CEN-257(O)-NP SUPPLEMENT 1-NP

# STATISTICAL COMBINATION OF UNCERTAINTIES

This supplement updates Part 1 of the original report (CEN-257(0)-P, November, 1983) to account for the changes made to the Fort Calhoun Station Unit 1 TM/LP trip. Because this trip has been modified to include explicit monitoring of the shape index, the descriptions of the protection system and the analysis of the net uncertainties and the reported value of the net uncertainty have been changed.

SUPPLEMENT 1 TO  
STATISTICAL COMBINATION OF  
UNCERTAINTIES  
PART 3  
(CEN-257(0)-P)

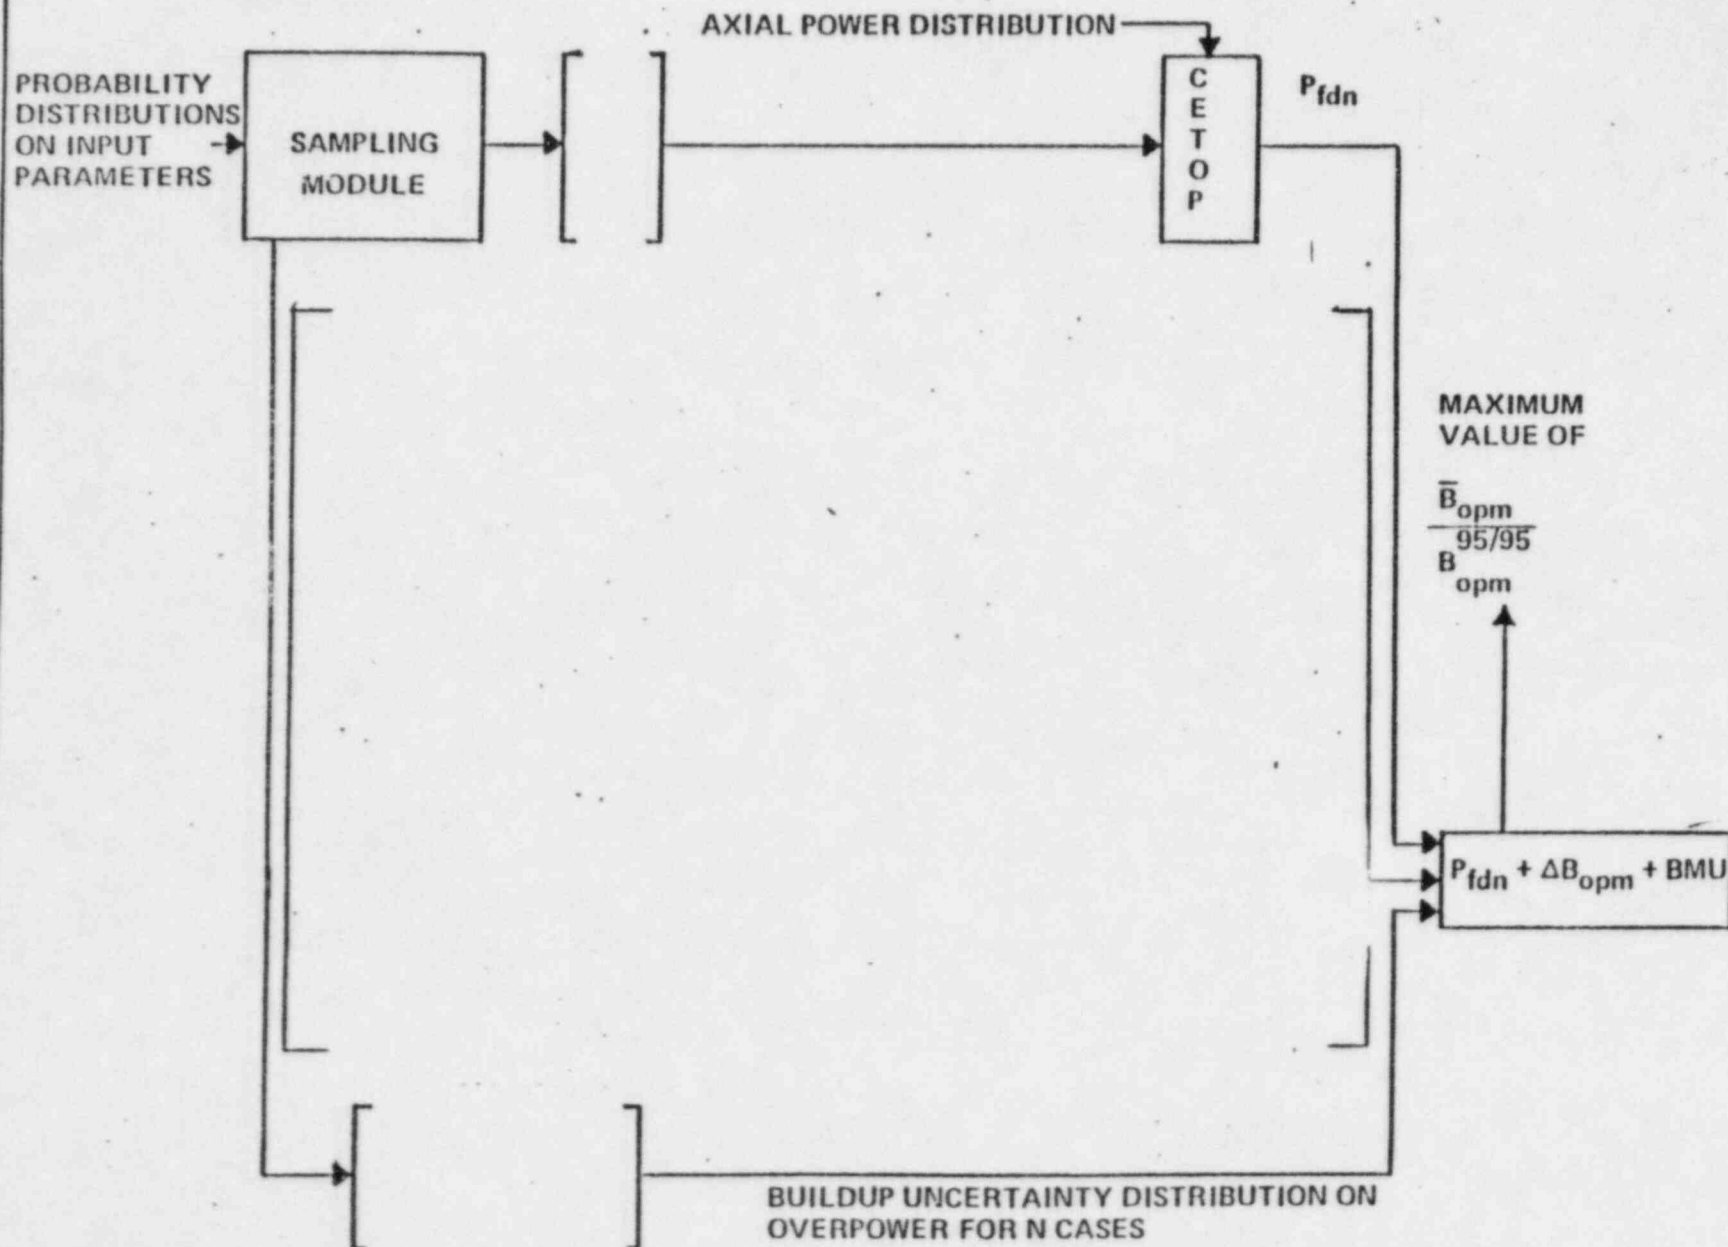
Figure 2-1 is a flow chart representing the ex-core detector monitoring stochastic simulation of the DNB limits. This figure is similar to Figure 2-1 in Part 1. Figure 2-2 is a flow chart representing the in-core detector monitoring stochastic simulation of the DNB limits. This figure differs from

Figure 2-1 in that the [

] stochastic simulation. The independent variables and their uncertainties are input to CESCU. Each data set generated by the statistical part of CESCU is evaluated with the CETOP-D portion of CESCU to generate a  $P_{fdn}$  probability distribution. The ratio of the mean value of  $P_{fdn}$  to the lower 95/95 value of  $P_{fdn}$  is the parameter of interest. The details of the specific DNB LCO stochastic simulations performed are presented in Section 2.4.
